County of Santa Cruz

Agenda Date: **October 28, 2026**

Subject: A public hearing to consider an appeal of the Zoning Administrator's decision to approve application 251357; a Coastal Development Permit and Variance to recognize the construction of a storage shed (approximately 234 square feet) located behind the existing residence on property located at 154 Sunny Cove Drive in the Live Oak Planning Area.

APPEAL TO THE PLANNING COMMISSION
Application No. 251357 — 154 Sunny Cove Drive, APN 028-221-16
Appellant: Milly Rose LLC, owner of 145 18th Avenue (APN 028-221-24)

JOB NO. V26077	SHEET 1 OF 1 SHEETS	APN 028-221-24	Results of Survey Map
		DATE 09/02/26	145 Eighteenth Avenue
		SCALE 1"=10' DRAWN VCL	Santa Cruz, CA

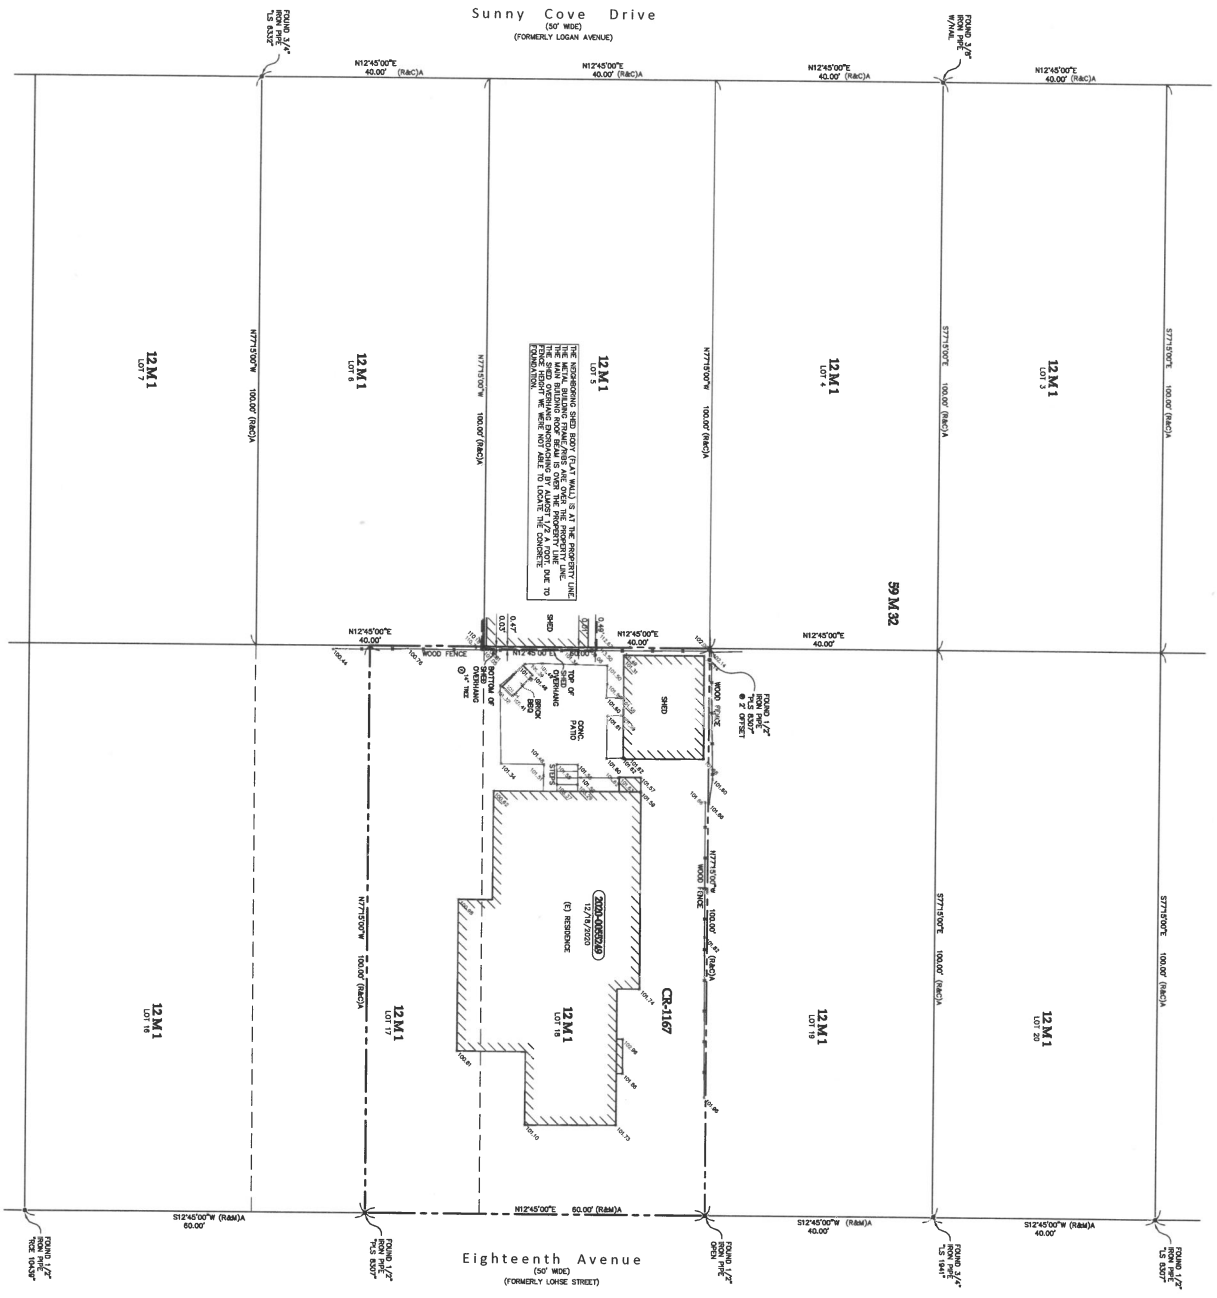
The survey at Exhibit A was completed on September 2, 2026 and is submitted signed and stamped. The appellant will provide any Record of Survey filed with the County Surveyor as soon as available. The appellant has requested further records from the County concerning the period from May 27, 2026 forward. All grounds stated in the written opposition and supplements filed August 18 and 19, 2026 are preserved.

4. Can the County approve a structure that a licensed survey shows is partly on the neighboring parcel? The approved plans show the walls two tenths and five tenths of a foot inside the property lines. The survey shows the building frame, the main roof beam, and the roof overhang over the line onto 145 18th Avenue. Which structure is the County approving? *(Exhibit A; Exhibit D of the staff report.)*

SITE PLAN

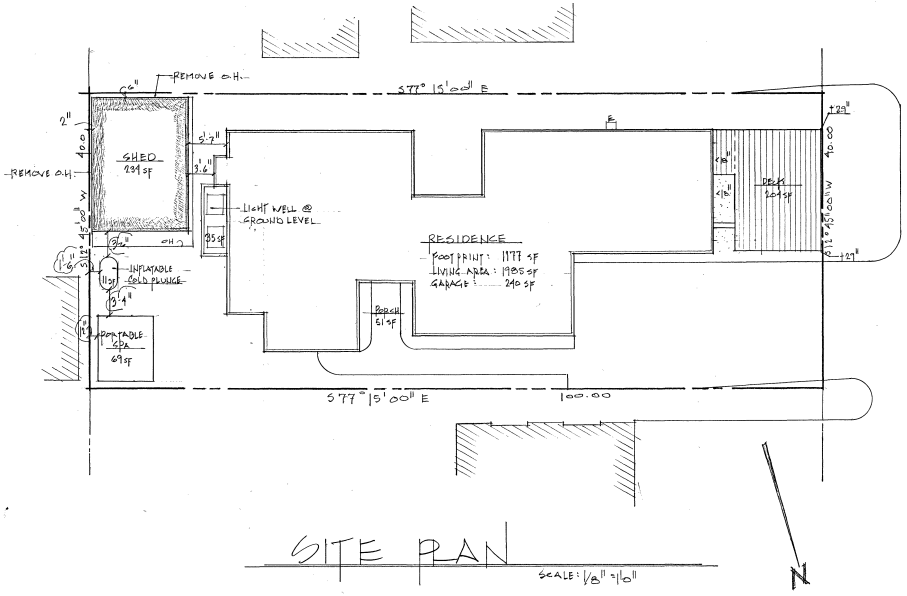
The approval describes a structure that is not there. Condition I recognizes the structure "as indicated on the approved Exhibit 'D.'" The surveyed detail on Exhibit D of the staff report, bearing the stamp of Jeff S. Nielsen, LS 6832, Mid Coast Engineers Job No. 25085, annotates the foundation at two tenths and five tenths of a foot *inside* the property lines. The measured position is at the line, with the building frame, the main roof beam, and the entire roof overhang beyond it. The cap of the appellant's fence is notched to receive the shed wall (Written Opposition, Exhibit C) — physical evidence that the wall was built to the fence, not held two tenths of a foot inside the line. The Zoning Administrator approved a plan set that misstates the only dimension the variance turns on.

The applicant's own surveyor drew the fence and the property line as separate lines. The Nielsen detail plots the "EXISTING FENCE" as a distinct line lying outside the "PROP LINE," and draws the shed inside the property line with clearance. Whatever assumptions may have been made during construction, the applicant's professional record shows that the boundary was identified, that it was known not to coincide with the fence, and that clearance was drawn which the structure as built does not have.

The eave line was never dimensioned to the property lines. The Nielsen detail draws a dashed "EAVE LINE" only on the two sides facing the applicant's residence. On the two sides facing the property lines it draws no eave line at all, and no dimension anywhere in the plan set states the distance from the roof edge to either boundary. The manufacturer's order sheet within the same approved plan set specifies roof overhang eaves of eighteen inches on Side A and six inches on Sides B, C and D. Six inches is half a foot; on the applicant's own annotated foundation offsets, the overhang crosses the property line on either surveyor's figures.

The figure is not merely narrative. It decides compliance with a site standard that was never varied. The lot coverage table on Exhibit D of the staff report totals 1,745 square feet and reports 43.6 percent against a 45 percent maximum. That percentage is derived from a 4,000 square foot denominator:

On the County's own recorded figure the project exceeds maximum lot coverage. No variance to lot coverage was applied for, noticed, or granted, so no finding cures it. Separately, the Project Data block on the same sheet states 1,651 square feet and 41 percent, contradicting the coverage table printed beside it.

The shed is existing and in place and was able to be viewed by staff and the Zoning Administrator prior to the public hearing. The walls of the structure appear to be located within the established fence line, but a formal survey has not been provided.

rear property lines and does not authorize the encroachment onto any adjacent property. Any eaves, overhangs, or other structural elements that may project into adjacent properties are proposed to be removed. If the structure is not located as indicated in the approved exhibit, the Building Inspector can require a survey to ensure that the structure is properly located on the subject property. If any portion of the structure extends across the property boundary, the building would need to be modified or reconstructed in order to comply with the 0 foot setback requirement.

Exhibit A. *View from the rear yard of 145 18th Avenue. The structure stands above the shared fence, with a window above the fence line looking into the yard. The shade it casts is visible across the yard.*

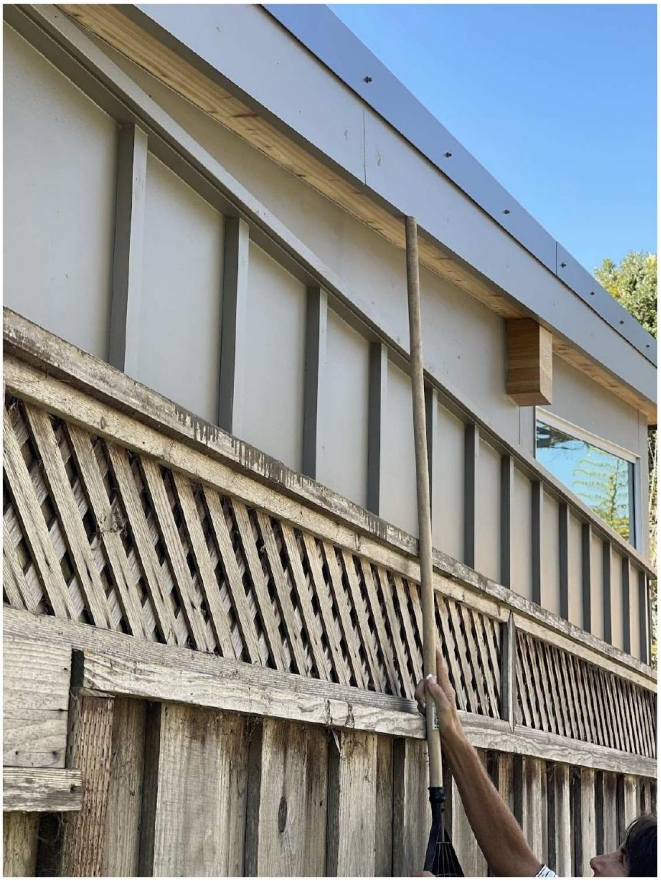
Exhibit B. *The roof assembly projecting past the fence line. The roof beam has been cut back at the line.*
